From: David Pickford <[REDACTED]>
Sent: 19 September 2019 14:16
To: Anita Gardner <[REDACTED]>
Subject: FW: 22 Beach Road, Littlehampton.

Subject: 22 Beach Road, Littlehampton.
Importance: High

I write further to the client providing me with your feedback on the AASL acoustic report dated 6th June 2019 for the above site.

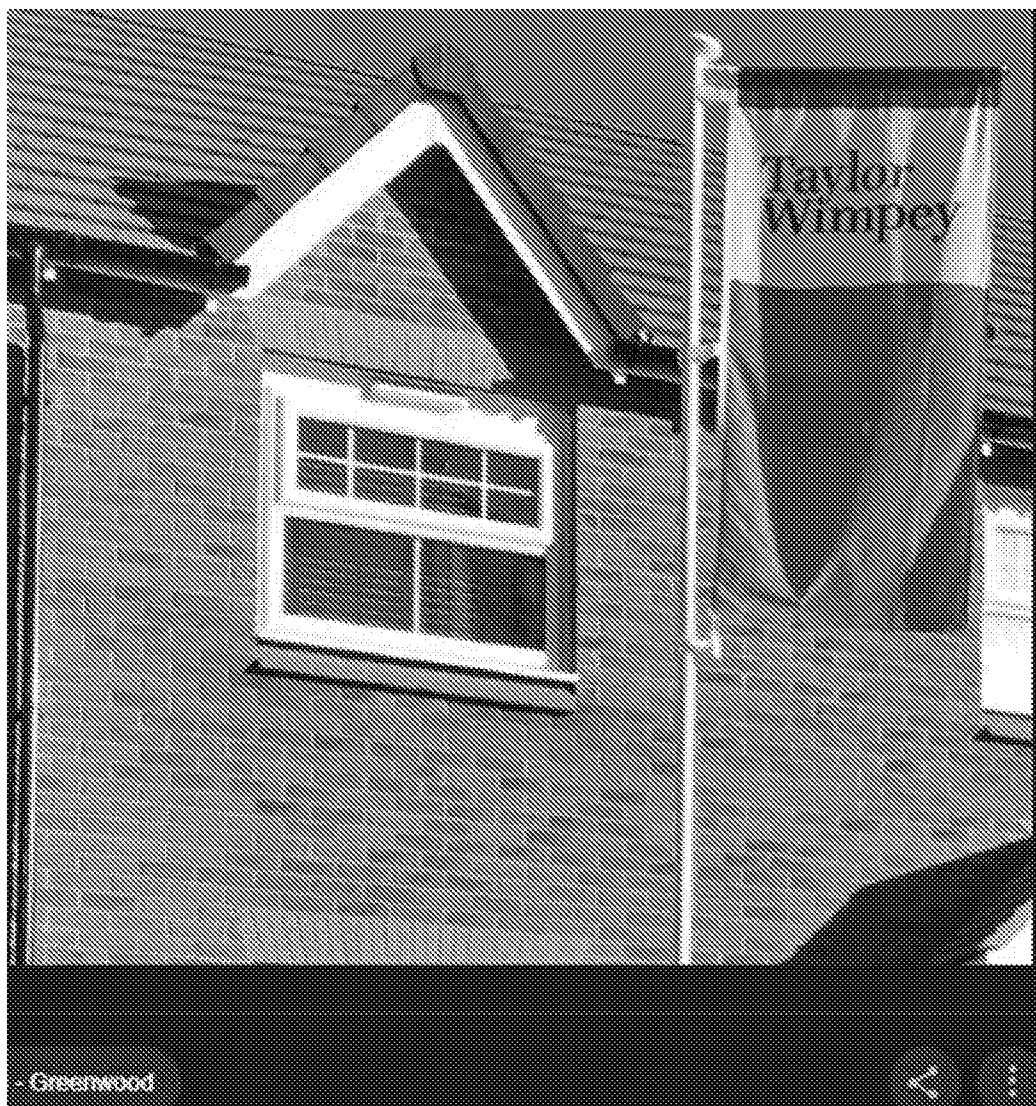
Before the applicant's noise consultants finalise their report in line with the discussions below with Carol Reynolds; as per below, can I get your confirmation that the proposed window acoustic vent (Greenwood 5000EA) shown on the attached specification sheet, required in relation to the noise mitigation discussed below, would be acceptable in terms of external appearance of the building please?

For reference, please see photo below of this vent installed to a window. As you can see the vent would have a negligible impact to the external appearance of the building and is arguably de minimis and does not require planning permission in itself.

For clarification, the vents will be installed in each habitable room.

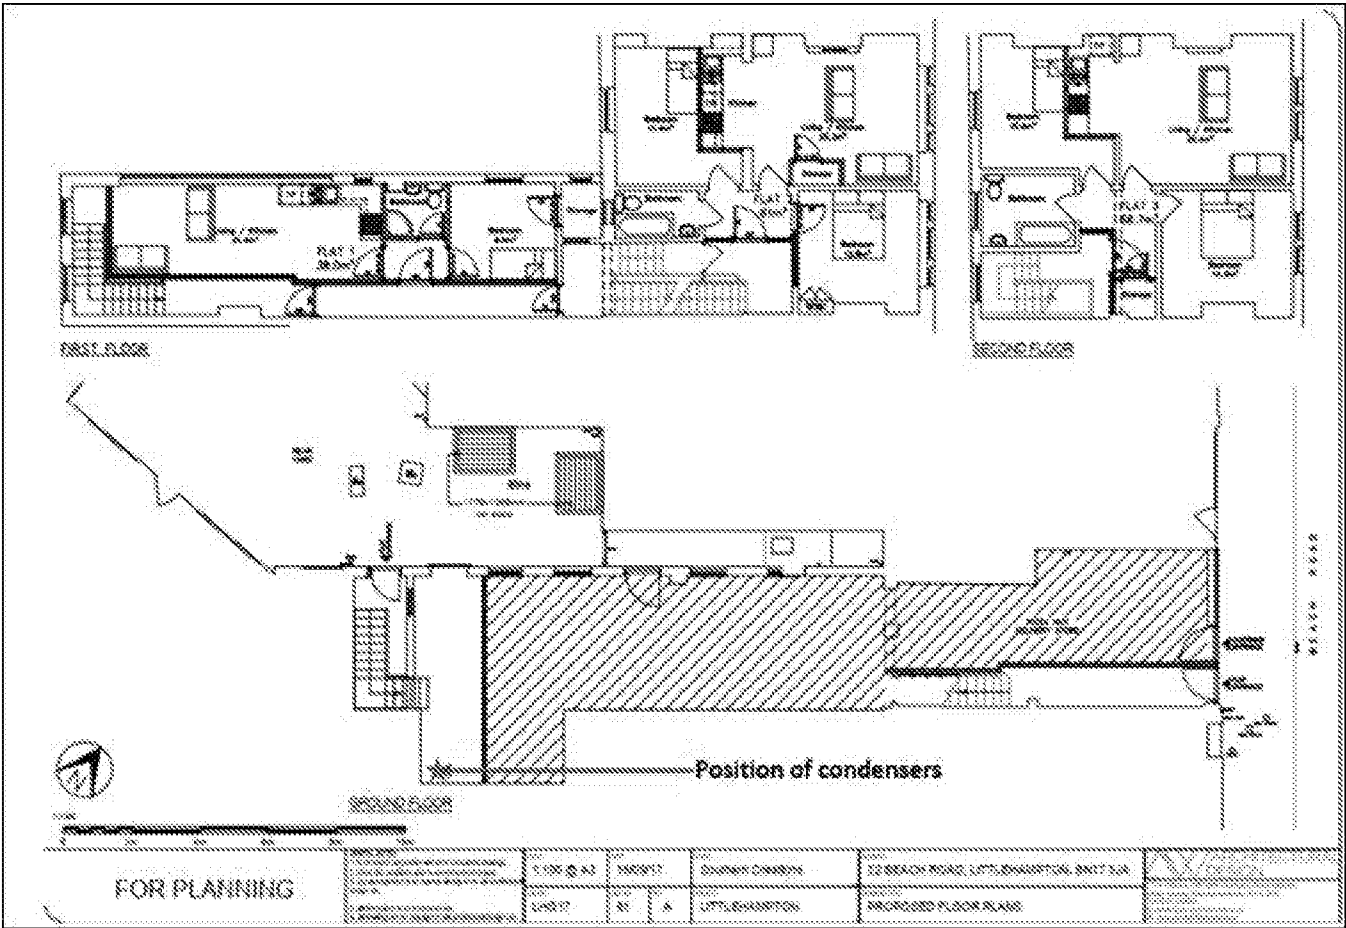
The condensers were previously located below the bedroom window but have since been relocated to inside the rear garage unit at the very rear of Flat 1, outside the demise of the flat.

The condensers are mounted on anti-vibration mounts on the ground floor. Both the garage and the pizza hut ceiling were soundproofed at the same time. The condenser positions inside the garage void are shown below.

The condensers would have run as part of the survey and are contained with the survey data.
